**DEQ Coal Combustion Residuals
Surface Impoundment
Closure Determination**

Belews Creek Steam Station

April 1, 2019

Figure ES-1: Belews Creek Steam Station October 2017 CSA Update Report

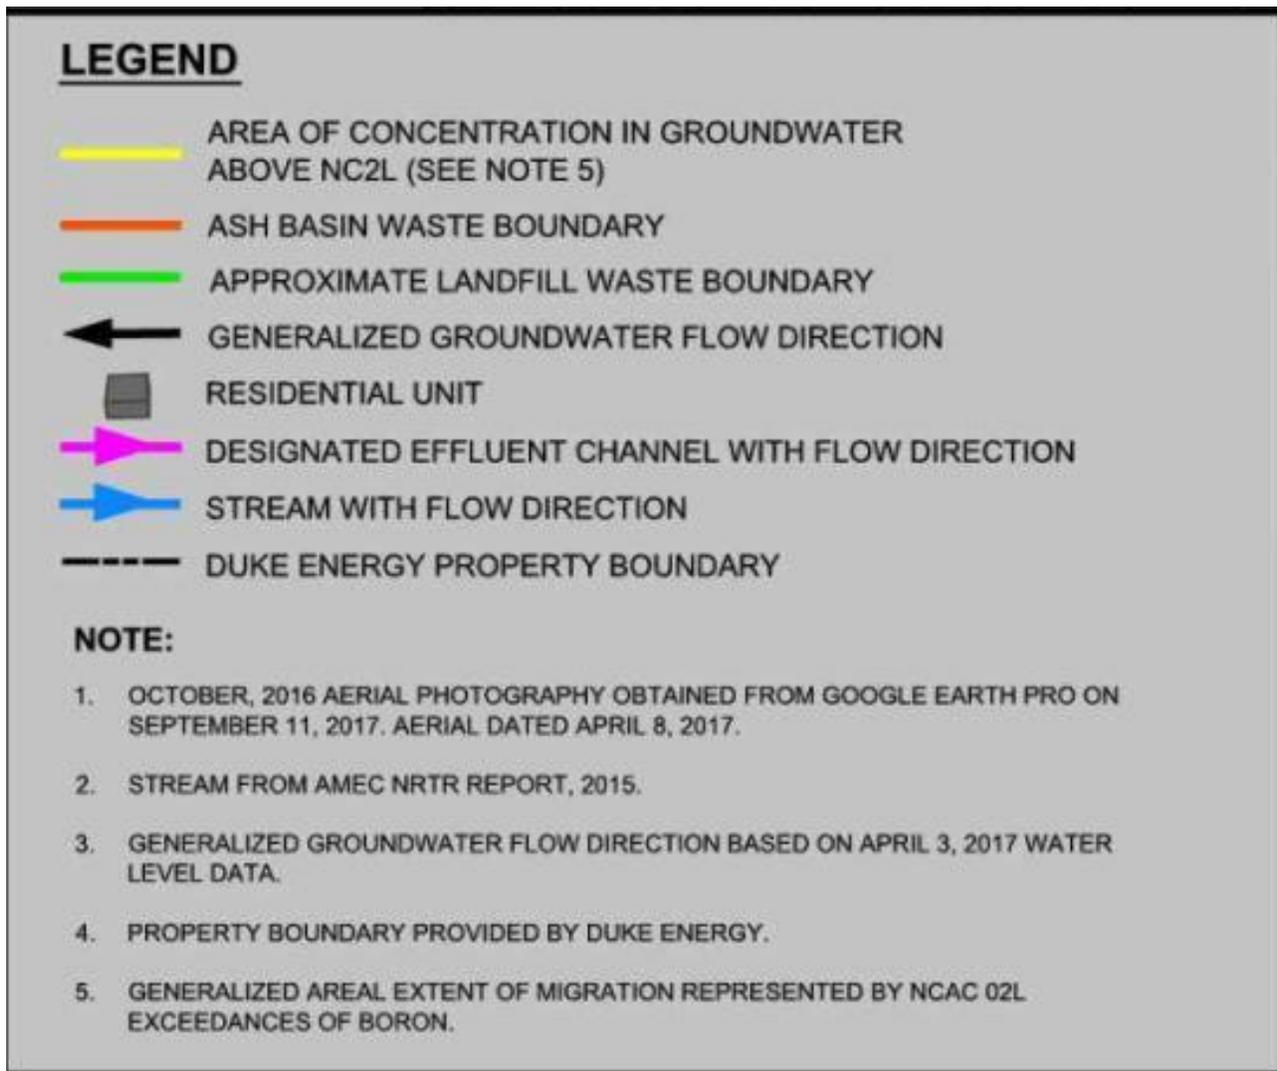
DEQ concludes that the contaminated groundwater plume above 2L standards has extended beyond the compliance boundary along the northern edge of the property. Based on Figure ES-1, this plume extends along the entire length active ash basin.

CROSS SECTION B-B' (VIEWED FROM DAM LOOKING SW)

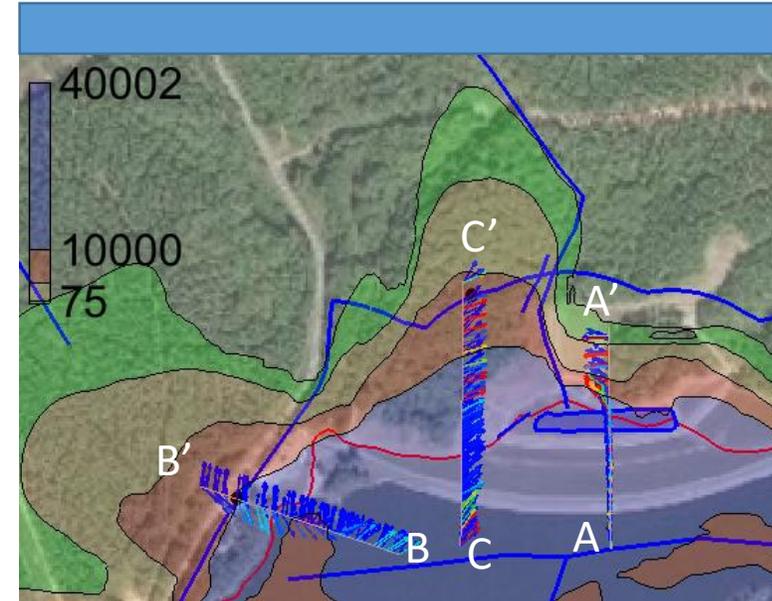
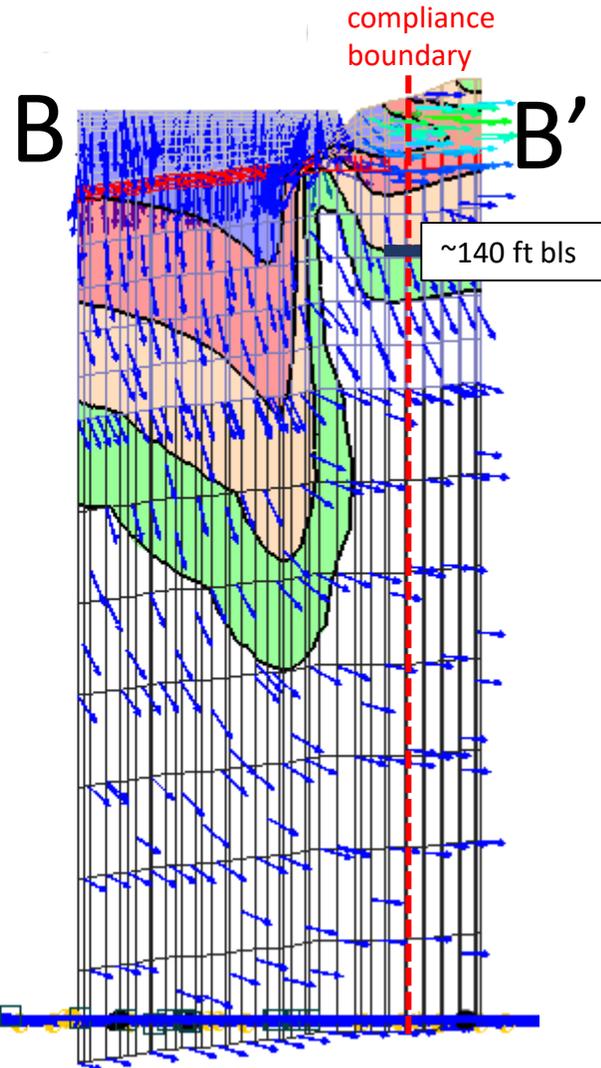
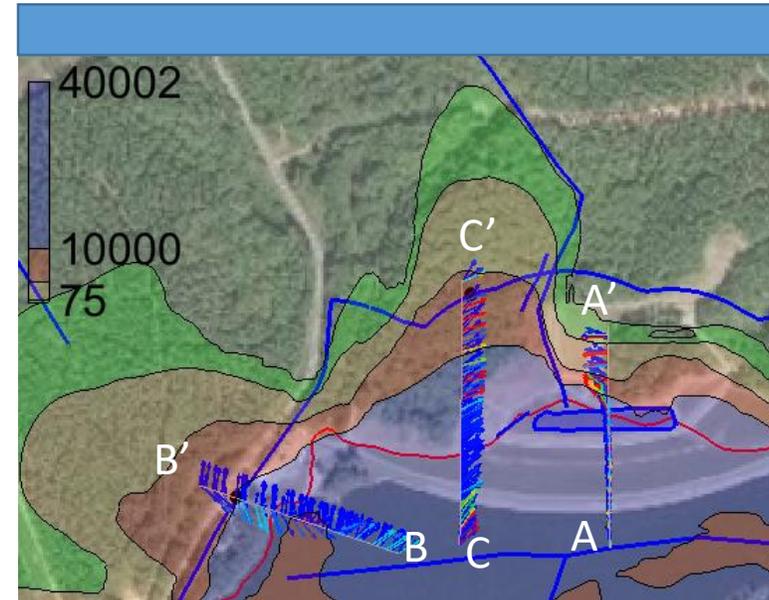
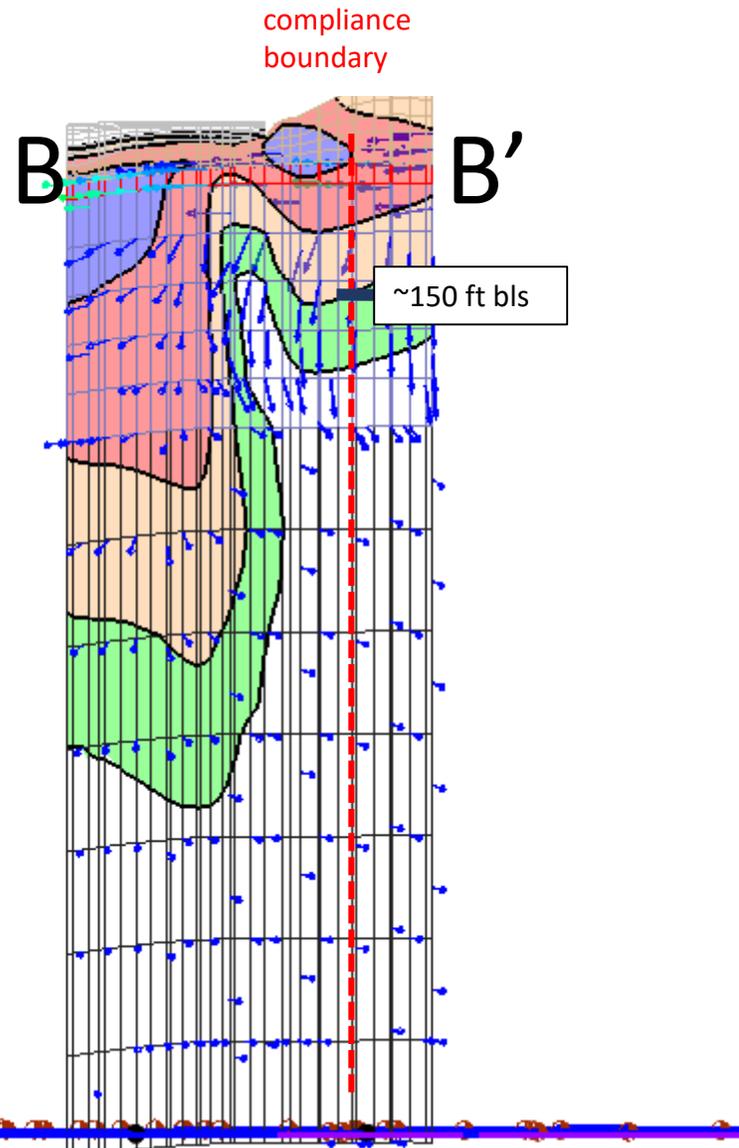
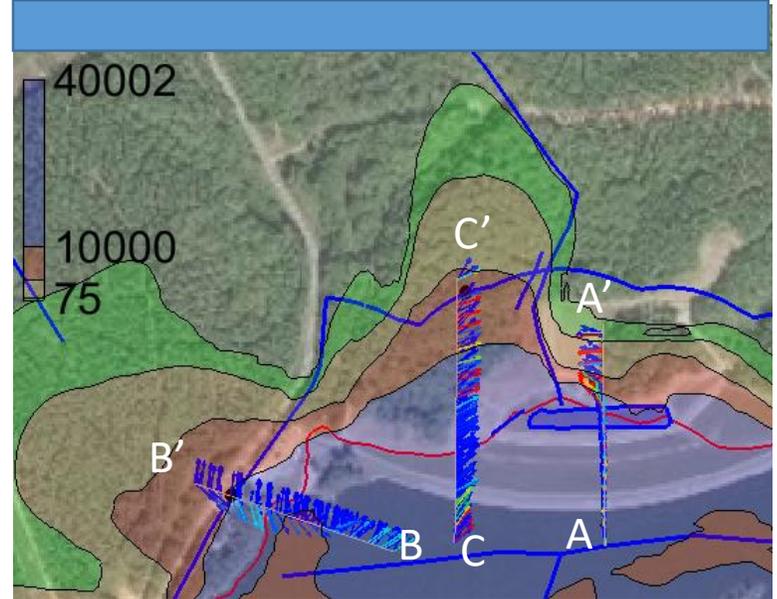
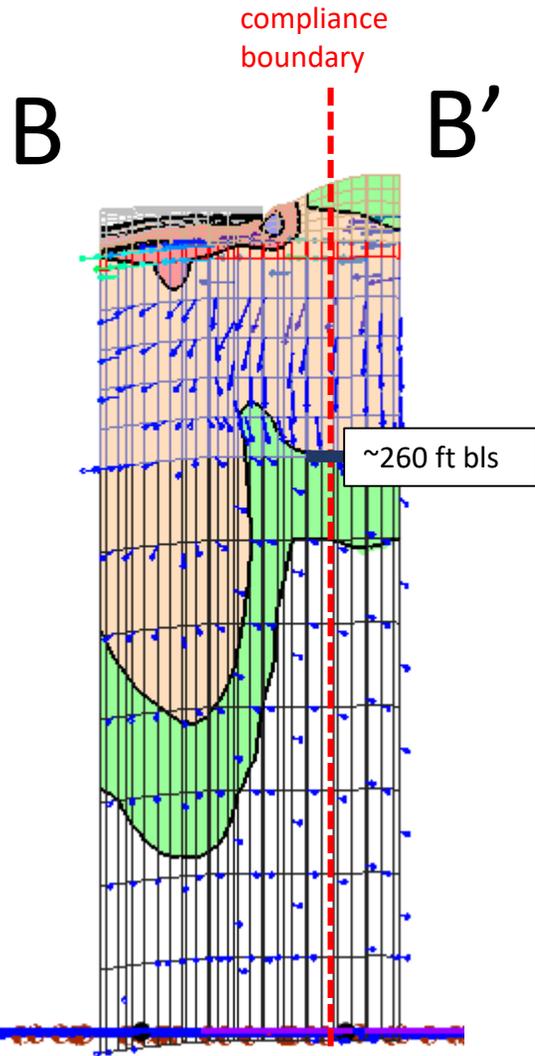
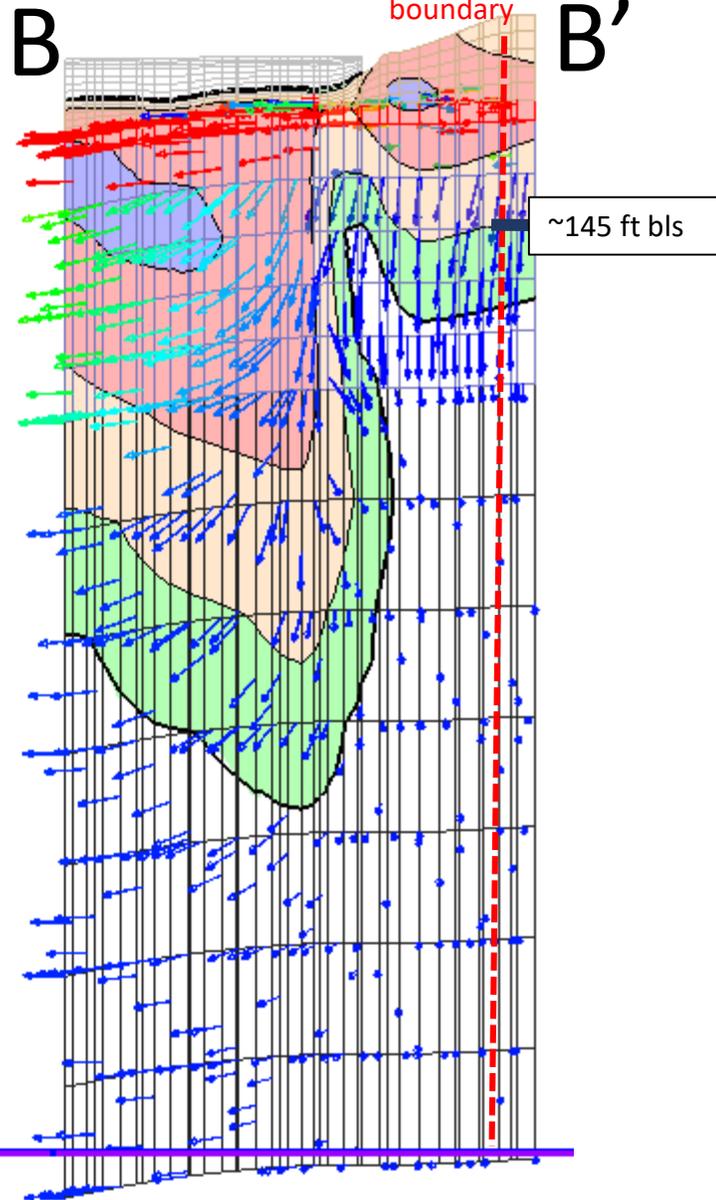
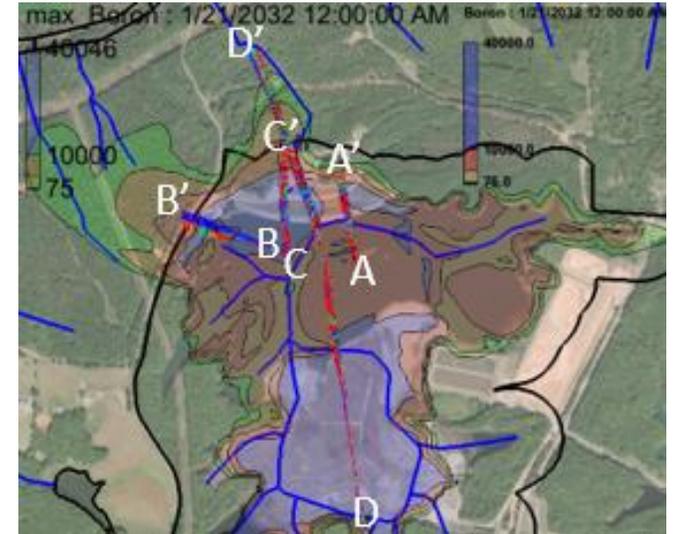
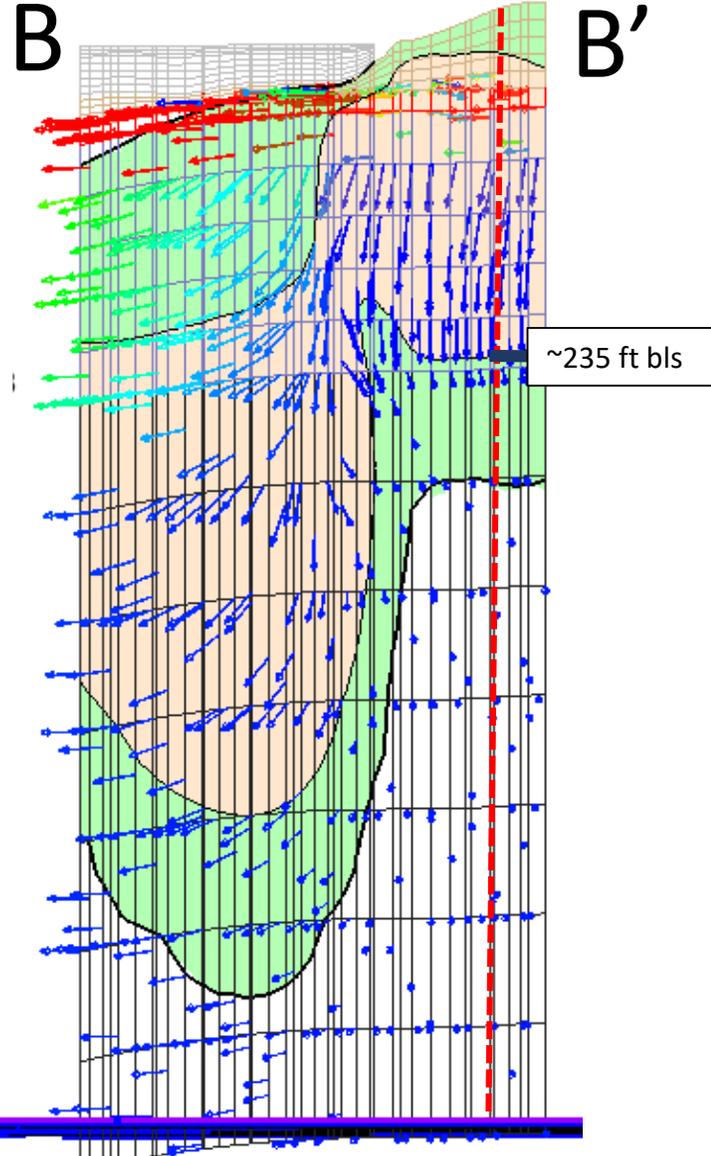
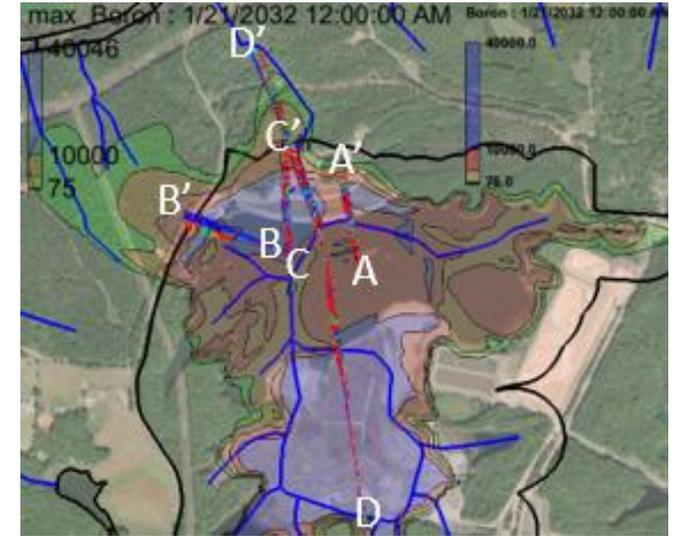
Belews Creek Modeling Results for Cross-Section B-B'			
Model Simulation	Maximum Concentration of Boron Above 2L Beyond Compliance Boundary (ug/L)	Depth of GW Contamination Above 2L Beyond Compliance Boundary (feet bgs)	Width of Contamination Plume Beyond Compliance Boundary (feet)
Current Conditions	4,000-10,000	140	1200
Completion of Final Cover (t=0 yrs)	4,000-10,000	150	1200
Final Cover (t=125 yrs)	700-4,000	260	700
Completion of Hybrid (t=0 yrs)	4,000-10,000	145	1200
Hybrid (t=118 yrs)	700-4,000	235	900

These data illustrate that after completion of closure with the final cover or hybrid option, the groundwater plume still extends beyond the compliance boundary above the 2L groundwater standard and the area of the plume requiring remediation is immense. Even 118 to 125 years beyond completion of closure, the area of the plume requiring remediation remains extensive.
